To: Planning and Zoning Board
Through: John Wesley, Planning Director
From: Lisa Davis, Planner II
Date: July 16, 2014
Subject: Z14-038 - Rezone from RM-2 PAD to LC PAD, Special Use Permit and site plan for Crescent Ridge Commercial Center (20± acres). This request will allow the development of a commercial center to include one big box retail user with attached shops, a gas canopy and with two drive through restaurants and one bank pad.

RE: PAD Overlay Narrative
PLN2014-00193 – Crescent Ridge Marketplace
Rezoning, SUP, and Site Plan Review
Planning & Zoning meeting July 16, 2014

N.W.C. Signal Butte & Guadalupe

Proposed Neighborhood Shopping Center

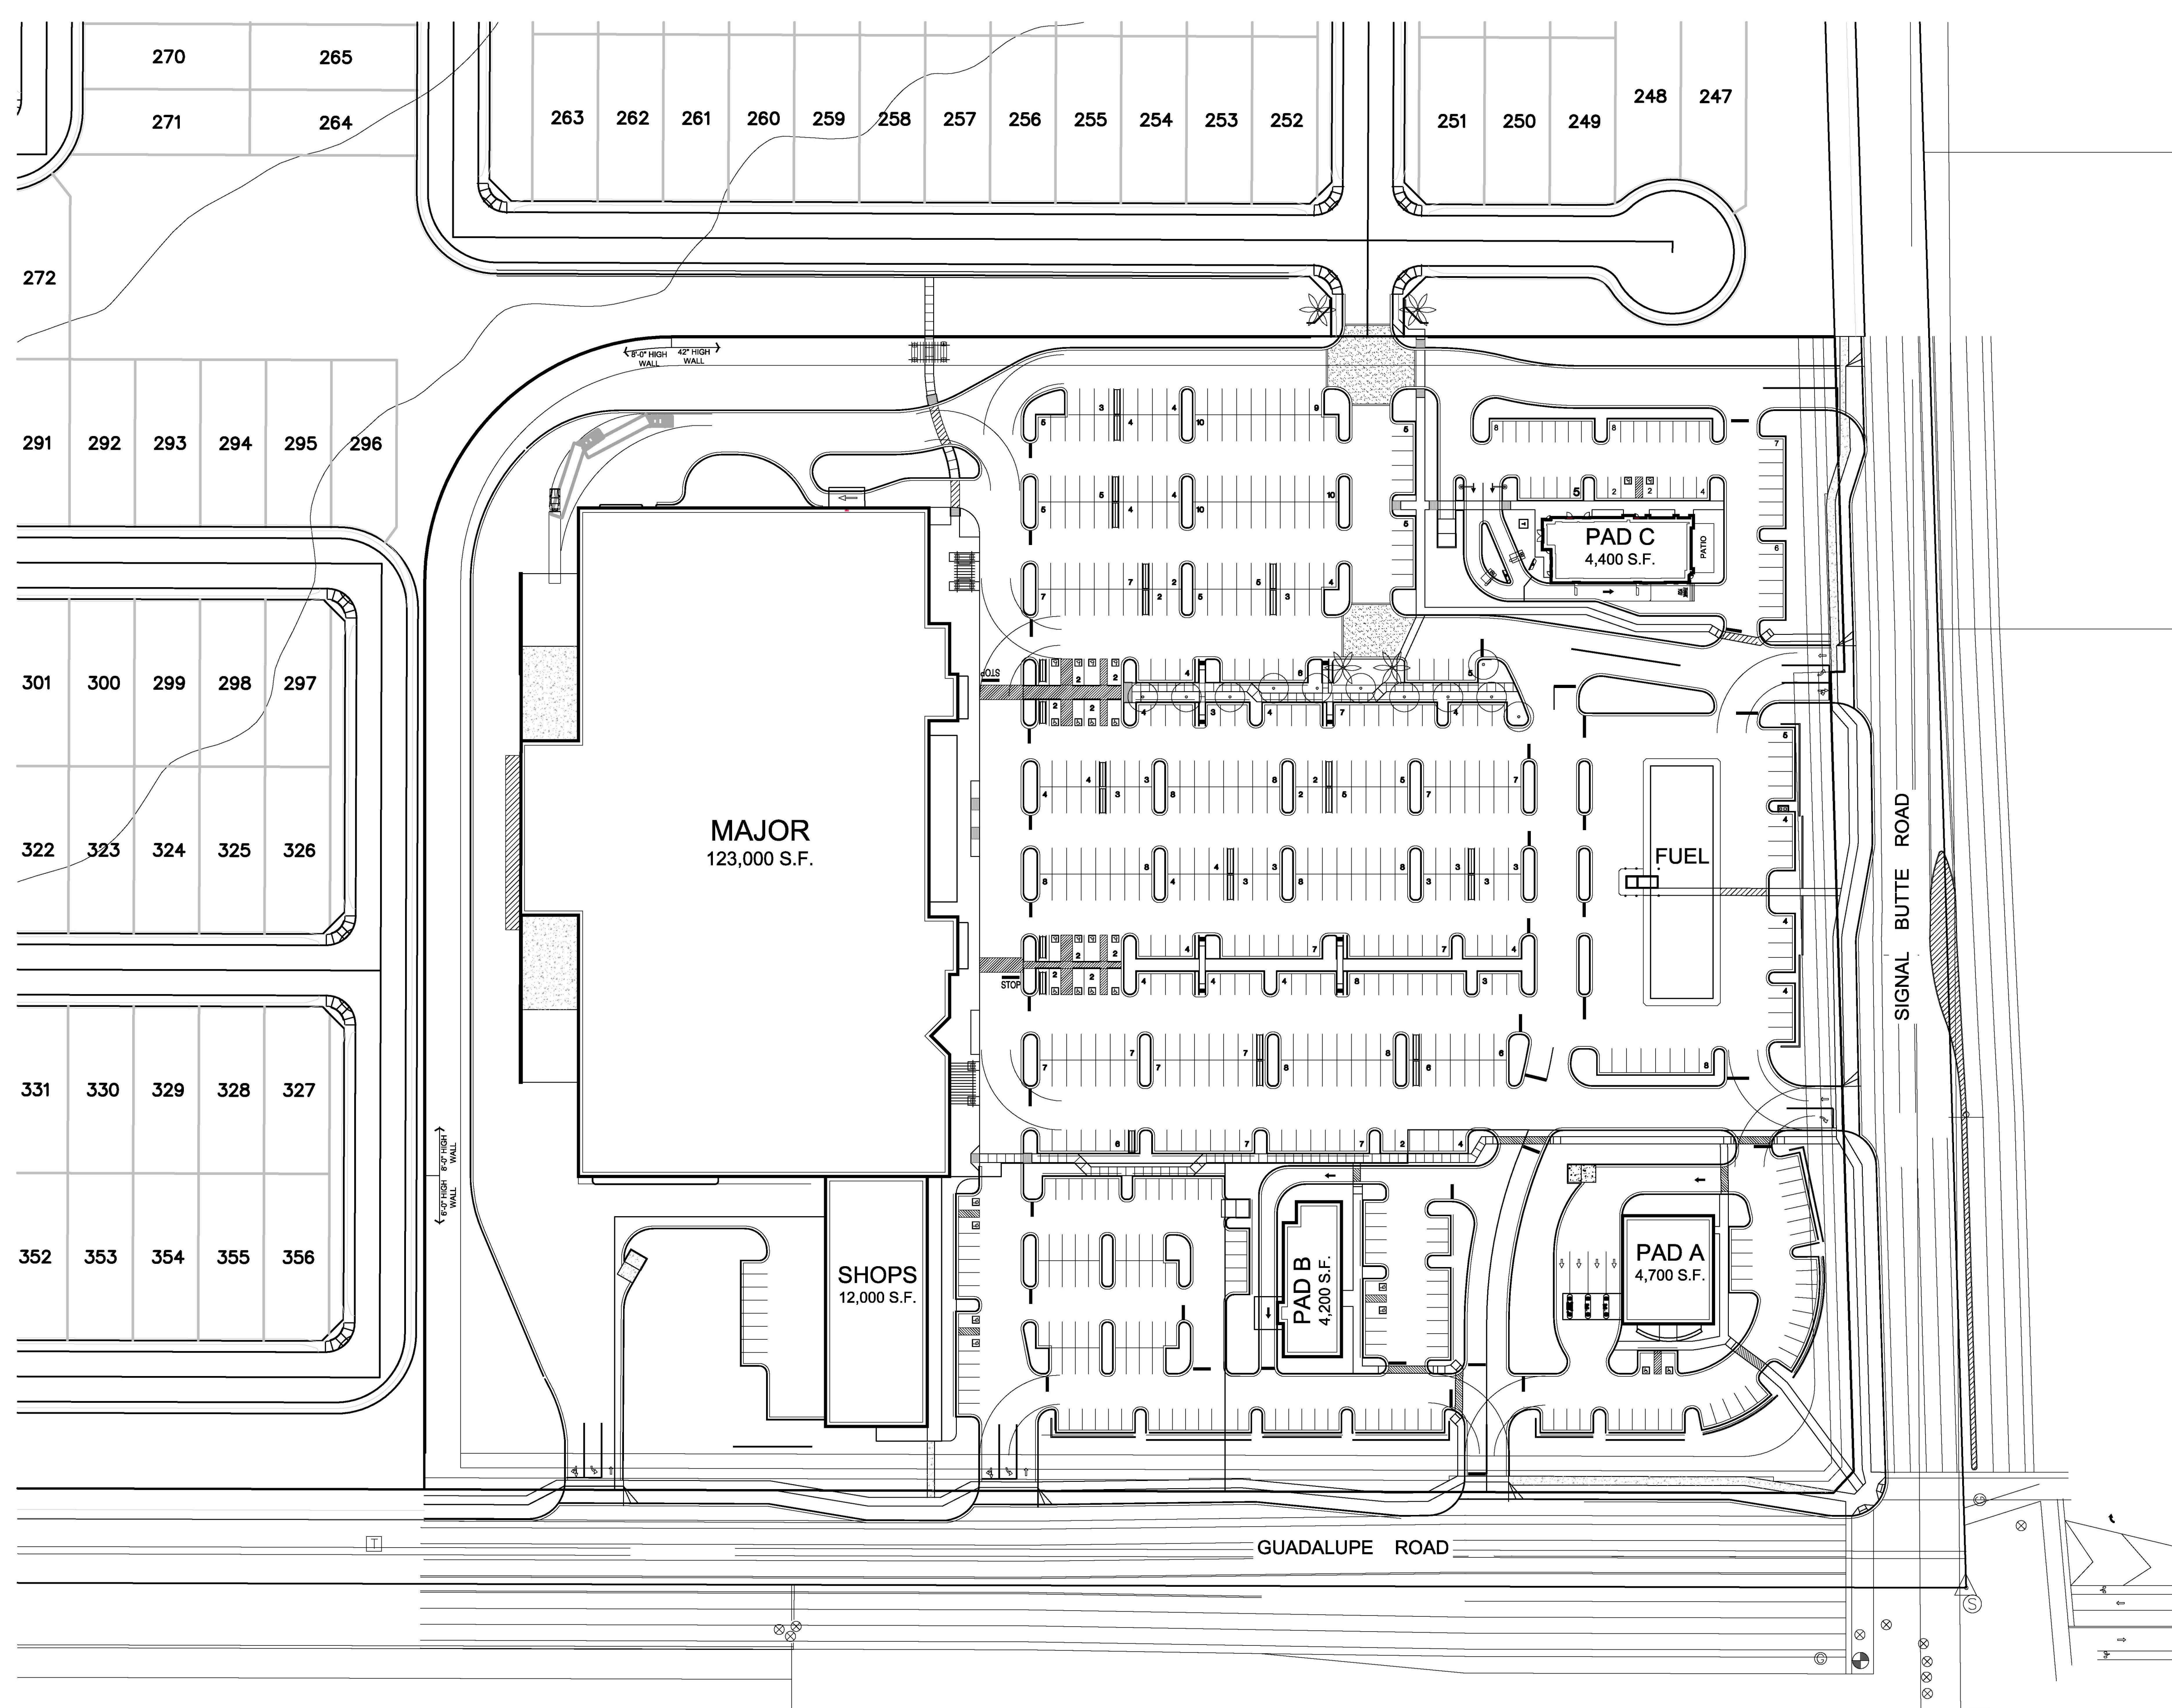
Section 11-30-9 of the Zoning Ordinance requires a minimum 6-foot wall along a common property line between commercial and residential developments. The goal and purpose of this requirement is to screen the noise, lights, and activity from the residential neighborhood. This is particularly important around the loading areas.

A goal from the beginning of this project has been to better integrate the commercial and residential developments to create a better sense of neighborhood. To accomplish this, the commercial and residential developers have been working together and have provided a street connection directly between the two sites at the north property line as well as a pedestrian connection to the front of the Fry's store. To allow for better integration of the two uses the applicant is requesting to reduce the height of the wall along the north side of the property. Consistent with code requirements, the commercial development is proposing a combination of 6 and 8 foot walls inside the west and north property lines of the site to block visibility of the loading dock area at the west side of the building. Along the remainder of the northern portion of the property, the applicant is requesting a deviation from the standard 6' wall requirement to a 42" high screen wall. The residential development is proposing 30' wide landscape area adjacent to the north property line. A consistent landscape palette will tie the two properties together and can be reviewed through the Design Review application. Staff supports this deviation from code.

A landscape setback of 20' is required along the north property line. The applicant is requesting a reduction to 8' of landscape setback. This will allow for additional parking spaces. Staff has concern with reducing the amount of landscape setback for additional parking. The amount of parking provided actually exceeds the maximum amount of parking allowed per section 11-32-3.C. The maximum number of parking spaces is 125% of the minimum number of required parking spaces. In this case, the required is 476, the maximum number of parking spaces is 595 spaces and they are proposing 628 spaces. This same section of the code does also

address process to exceed the 125% that includes an Administrative Use Permit. However in order to obtain the Administrative Use Permit additional landscape is required for the site. Therefore, staff does not support this request because it is contradictory to the requirements, purpose and applicability of the Zoning Ordinance and as a new build, large green-field site they should be able to meet the code requirements.

A landscape island is required every eight consecutive parking spaces. The applicant is requesting to reduce the number of landscape islands in order to gain additional parking spaces for Fry's Marketplace. They are proposed at the north side of the site between the Fry's building and Pad C. The request is to allow a landscape island to be placed one every nine to ten spaces as opposed to the required one to eight. This would be a reduction of 3 parking islands to allow for additional parking.

As noted above staff cannot support a reduction in landscape for an increase in the number of parking spaces when the site exceeds the maximum amount of allowed parking spaces. Therefore, staff does not support this request because it is contradictory to the requirements, purpose and applicability of the Zoning Ordinance.

The current site plan, with the requested reductions in landscape area, provides 628 spaces, 33 over the maximum allowed. If the required landscape areas are provided the project would then have 609 parking spaces, still 14 over the maximum allowed by the zoning ordinance. The applicant has stated that the requirements for the Fry's Grocery store to locate on this site is to have the 628 parking spaces, this is why they have requested the modifications to the required landscape areas. In practice, we never see any of these parking lots totally full, even on the busiest days. Knowing the parking spaces are important to the major tenant, staff could support the deviation from code to allow 609 spaces to be provided on the property.

6. The landscape setback at the north property line shall be the ordinance required 20'.
7. Landscape islands shall be installed at one per every eight parking spaces as required by code.

8. The maximum number of parking spaces allowed will be 609.
9. Submission of a revised site plan consistent with Council conditions of approval prior to Design Review approval.
